From: Scala, Mary Joy
Sent: Thursday, July 28, 2016 11:22 AM
To: Ehman, Doug
Subject: BAR Action - Downtown Mall between 6th and 7th Street East End - July 19, 2016

BAR 16-07-07

Downtown Mall, between 6th Street and 7th Street

Move lamp posts & install synthetic tree grates

FIGURE 5

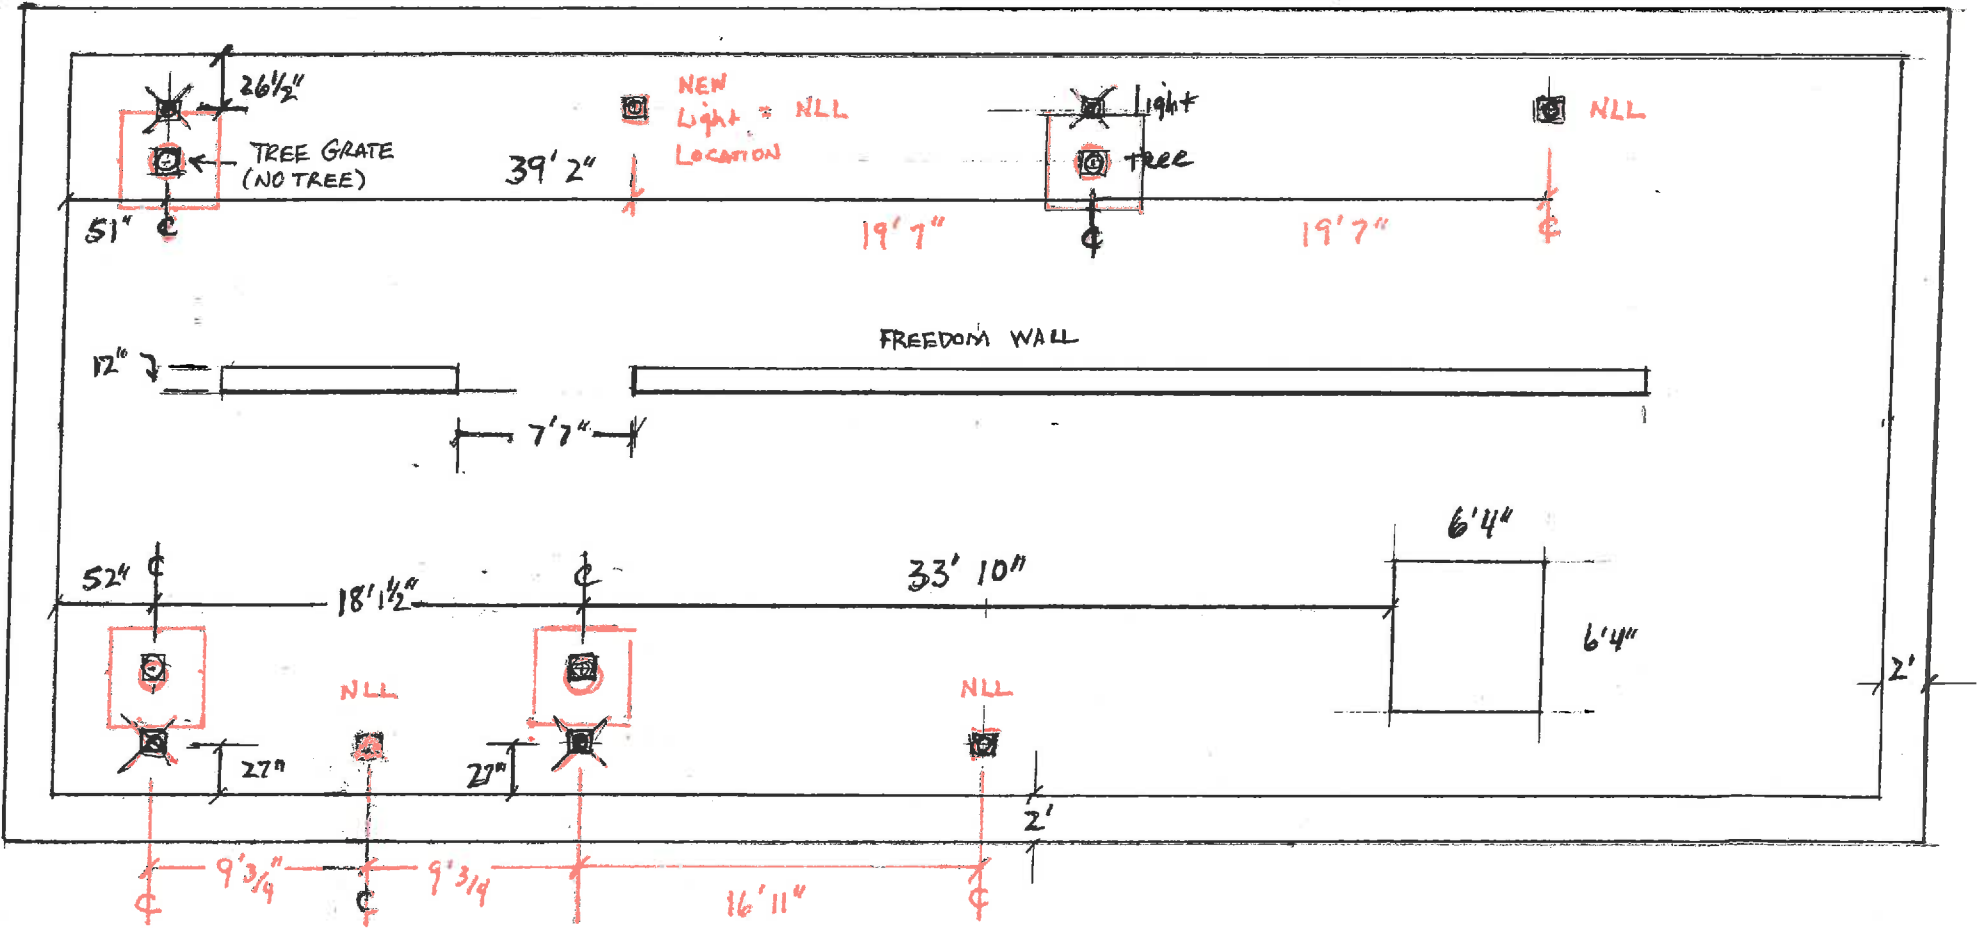
Balut moved to find that relocating four light poles as submitted does not satisfy the BAR's criteria, and we stipulate that Mary Joy and at least two members of the BAR will visit the mall to verify the new lamps will be compatible with this property and other properties in the Downtown ADC district, that the BAR will approve that new layout administratively after that meeting takes place. Schwarz seconded. Motion passed (7-0).

Staff agrees the light poles should be moved, but recommends that the new light pole layout (location, orientation, number of lamps) should be designed by a professional. The existing light poles associated with a tree and the light poles adjacent City Hall have one lamp oriented north-south. Other freestanding light poles in the area have two lamps oriented east-west.

1. Move all four lights further north or south so their bases abut the granite strip (similar to the single lights just west of this area in front of the Post Office).
2. Your east-west dimensions look fine except for the light near the speaker podium, which should align with the tree opposite. Let me know if you have any questions.

The first attached drawing with green edits is administratively approved.

FIGURE 4

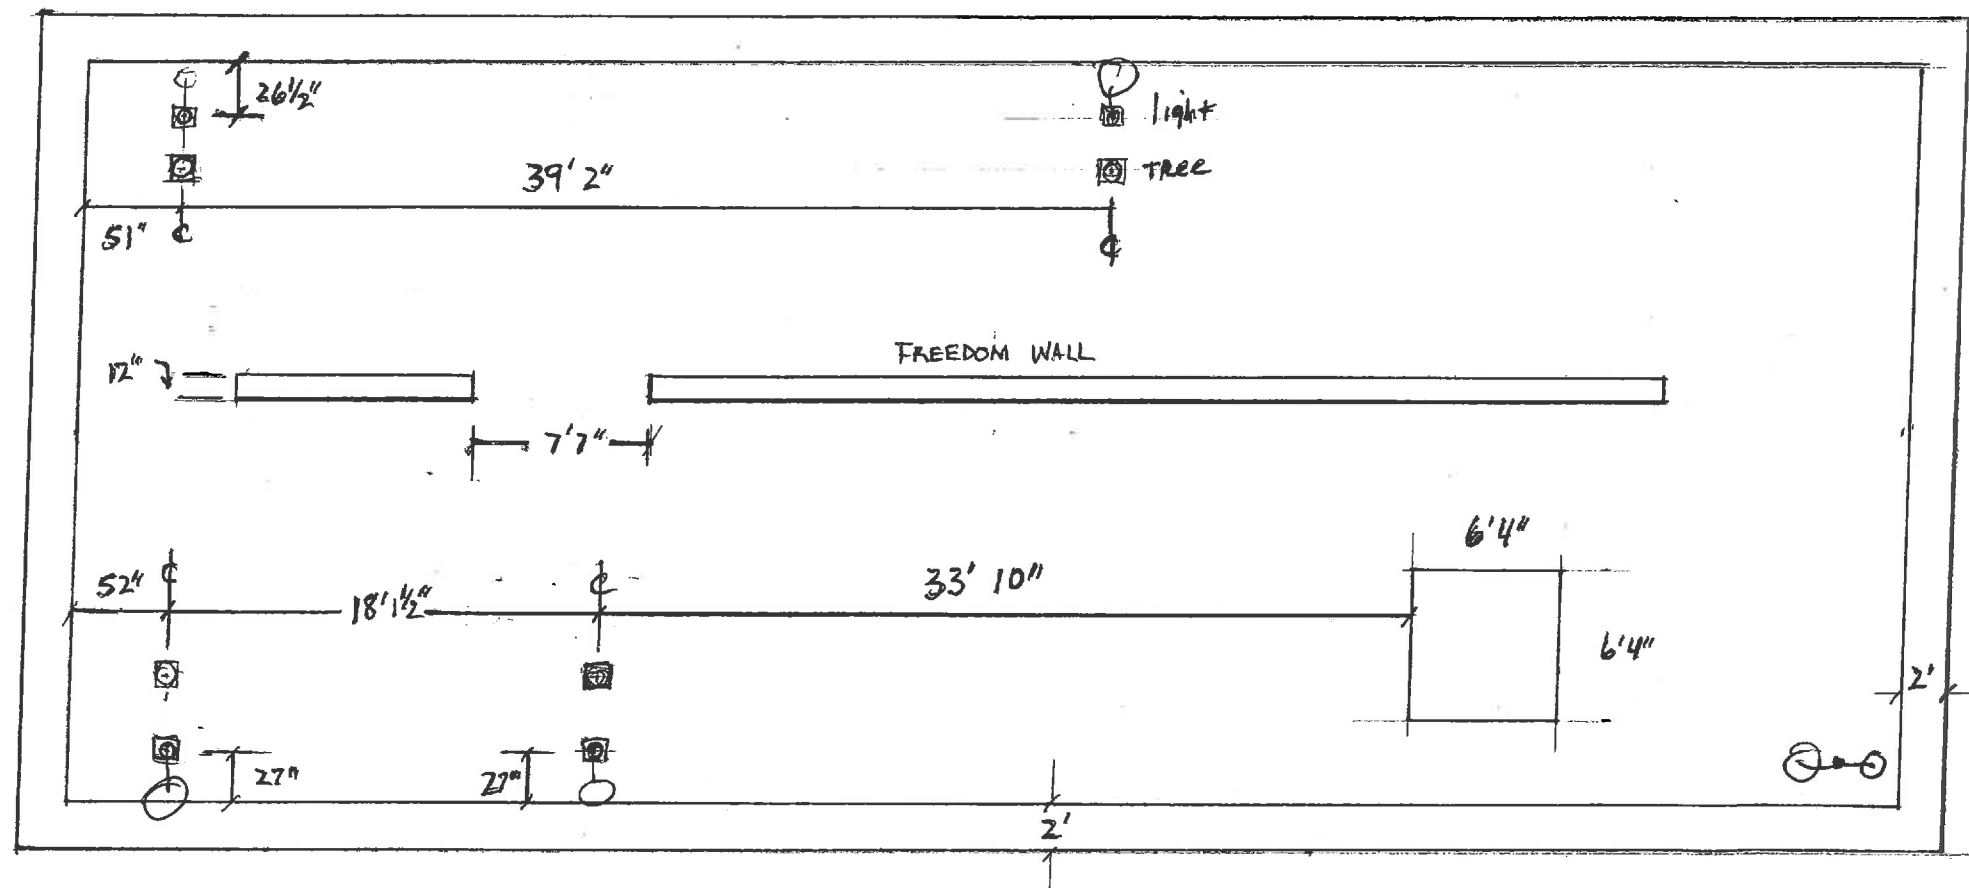
The four lights at the Freedom Wall are extremely close to the trees (Figure 4) and must be moved to prevent damage to the light base and to allow for tree growth (Figure 5). The light fixtures are within the crown of the trees and their location impedes the proper dispersal of light and is interfering with proper root development and would need to be moved within the next 3-5 years if not done now. We are proposing to take the far western light on the north side of the wall and place it more or less in line and equidistance between the two trees. The second light on the north side will move to the east the same number of feet as the first light is from the trees (Figure 5). The far western light on the south side will be placed midway between the two trees on that side. The second light will be placed midway between the tree and the speakers platform. We will use the existing lights in the same orientation and mount them on a concrete base utilizing the same base covers. The existing bases may be moved and will be used as electrical junction boxes for electrical feeds.

FIGURE 1

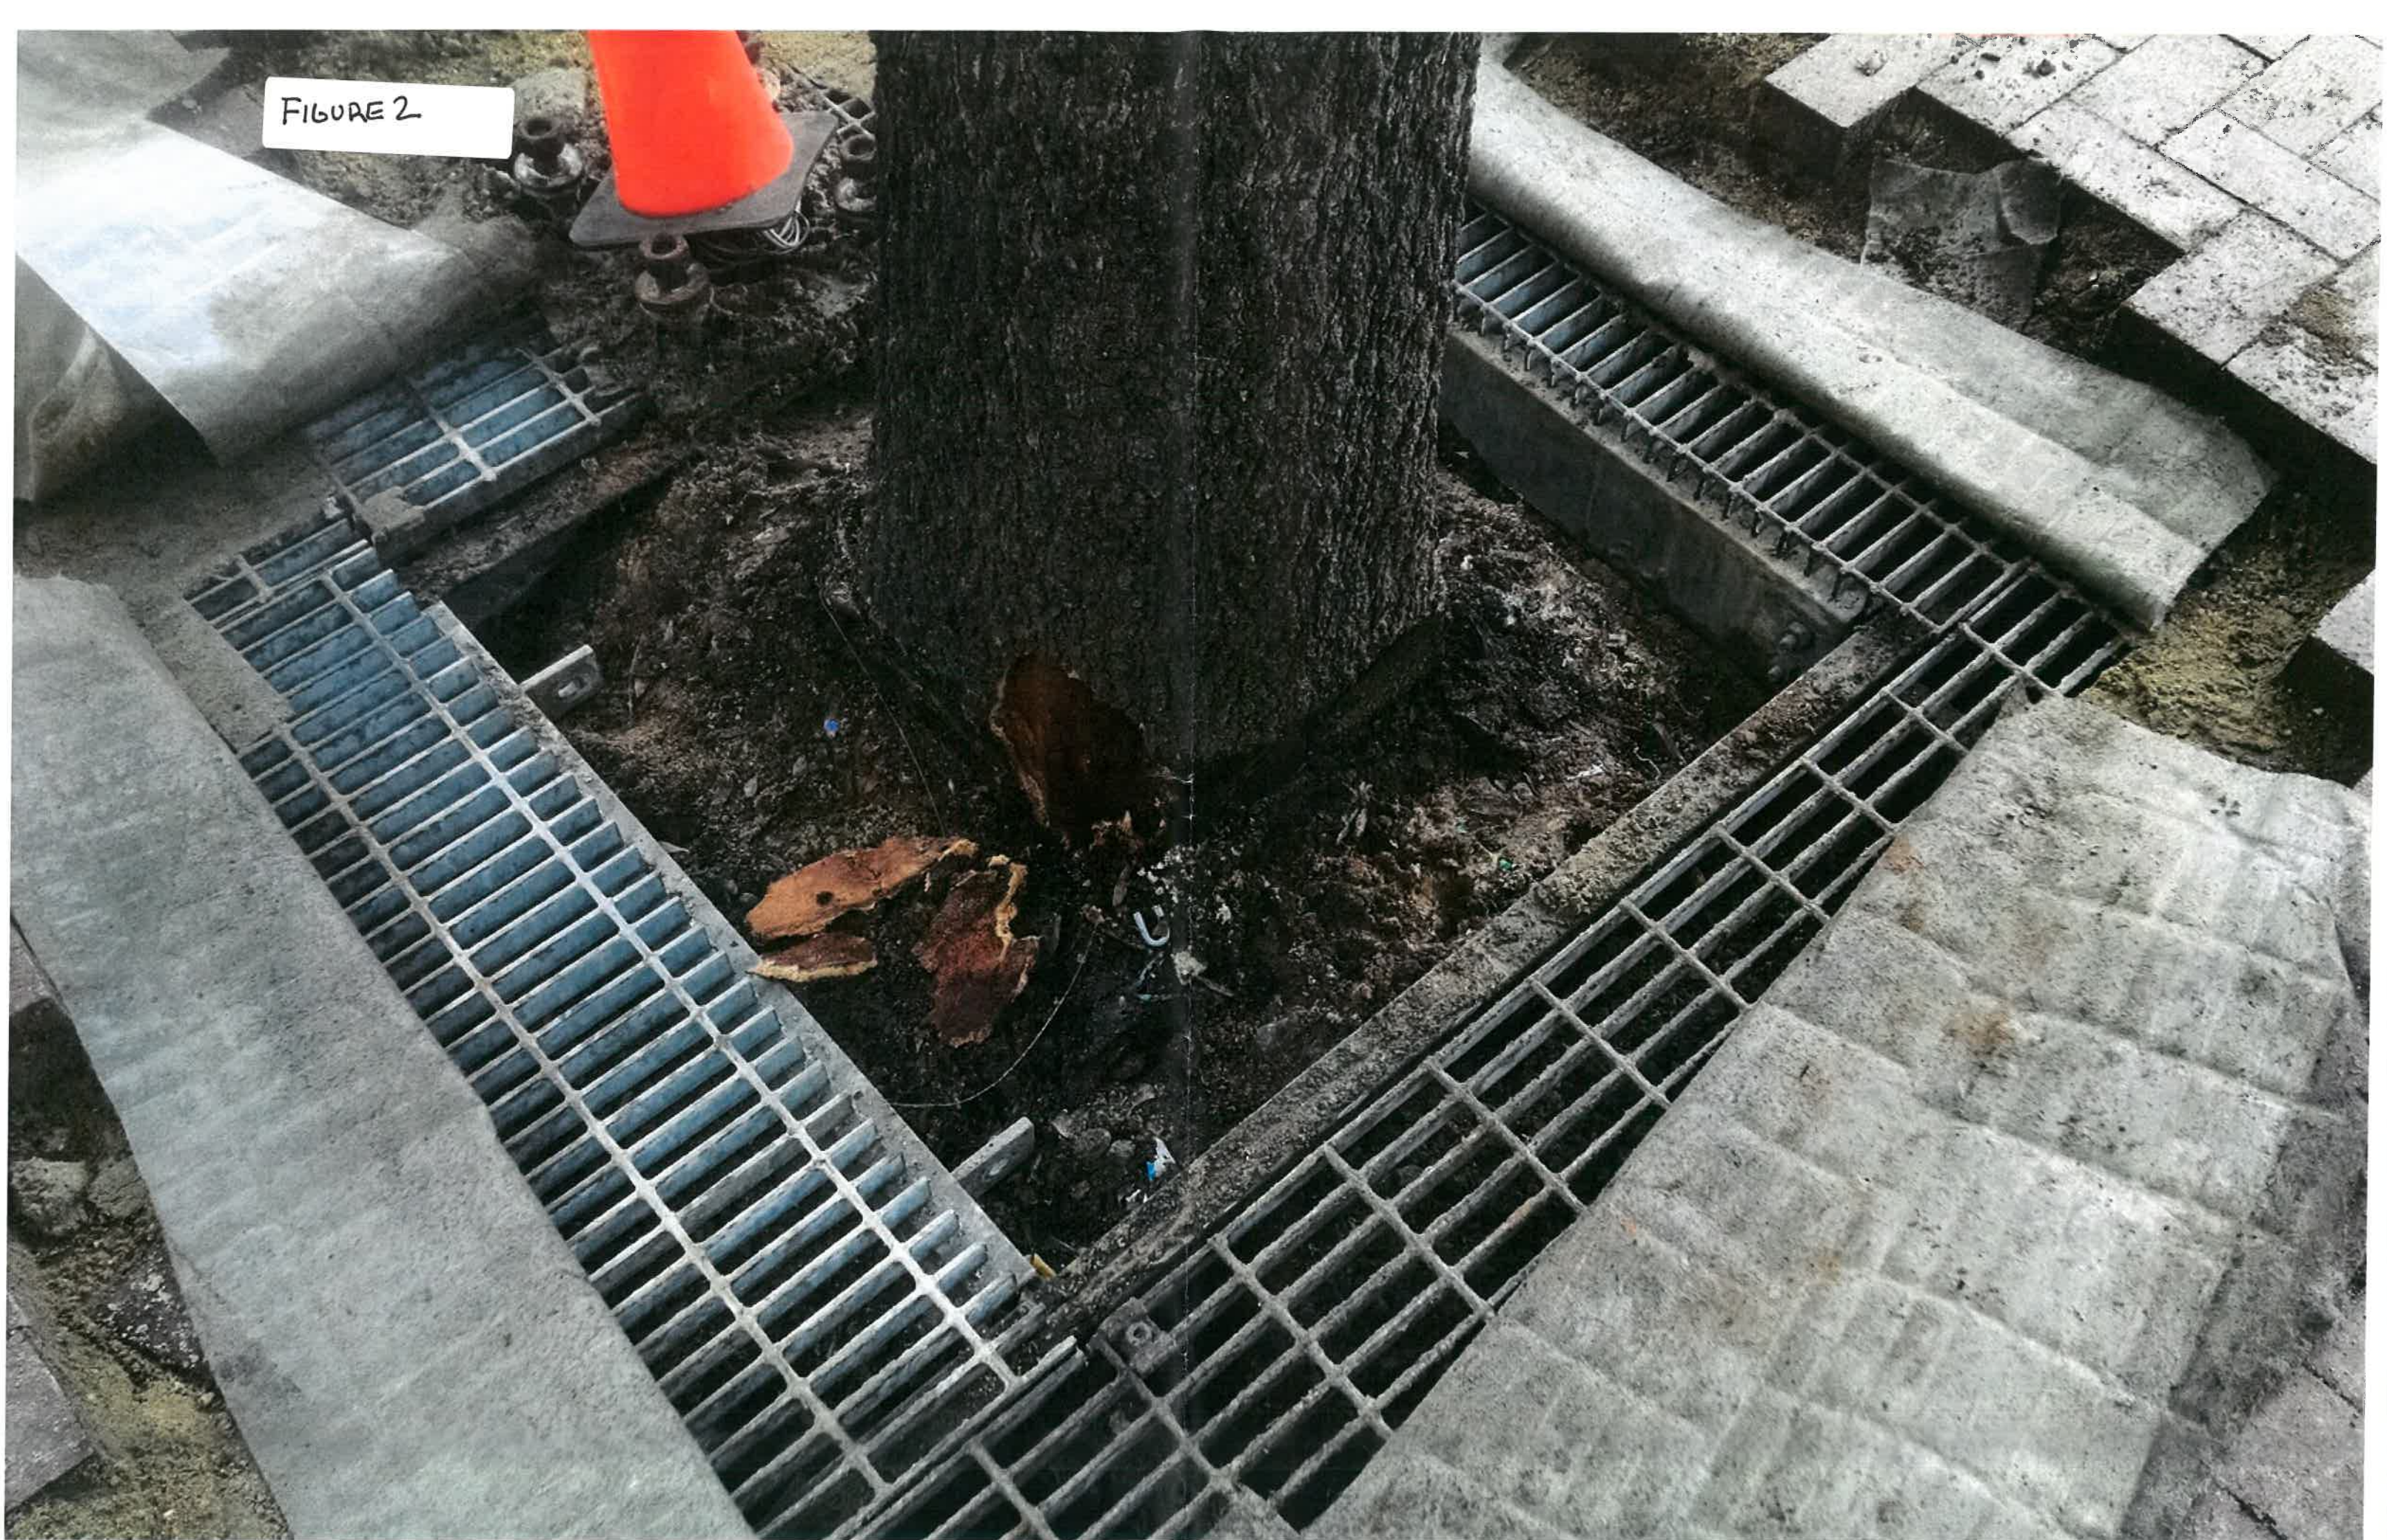
Balut moved to find that the redesign of ten tree grates does not satisfy the BAR's criteria and is not compatible with this property and other properties in the Downtown ADC district, and that the BAR recommends that the grates located around damaged or threatened trees may be temporarily replaced by plastic grates, for no longer than six months until another solutions is found to replace those grates with metal grates that are similar to the existing grates on the Downtown Mall. The cantilever frames are approved as submitted. Knott seconded. Motion passed (7-0).

Regarding the tree grates, staff understands the need to be practical, and this part of the Mall is not part of the older construction, but there must be a better solution than the proposed plastic grates. If the plastic grates are allowed, they should be neatly cut. Other options are metal grates or cantilevered brick. The attached plan by WRT suggested brick surfaces in combination with gravel near the tree, to allow the tree to grow without creating excess space for someone to step into.

There are currently a total of 10 trees in the non-Halprin/Pavilion section of the mall which have out grown their current tree wells which are negatively impacting these trees. There is one additional well that is currently vacant, but will be replanted. This request only covers the trees on the east end of the mall in close proximity to the Freedom Wall and the Pavilion and not any of the Halprin designed mall. Most of these trees show signs of degradation and will be critically impacted this growing season if no action is taken. At the present time pavers come up to the butt of the tree (Figure 1) The framework and system that supports the brick and grate around the trees, was designed to allow growth by a connection layer of galvanized channel steel, a large grid grate (similar to a grate in a sidewalk over a steam tunnel), fabric and sand. The first part of this framework is a larger grid of galvanized channel, welded and bolted together. This larger framework is incrementally placed for expansion as is the additional members in the system. The next is the large galvanized grate with approximately 1'x 2' hole. On top of that grate is a fabric to hold the sand that the brick pavers are set in. (figures 2 & 3).
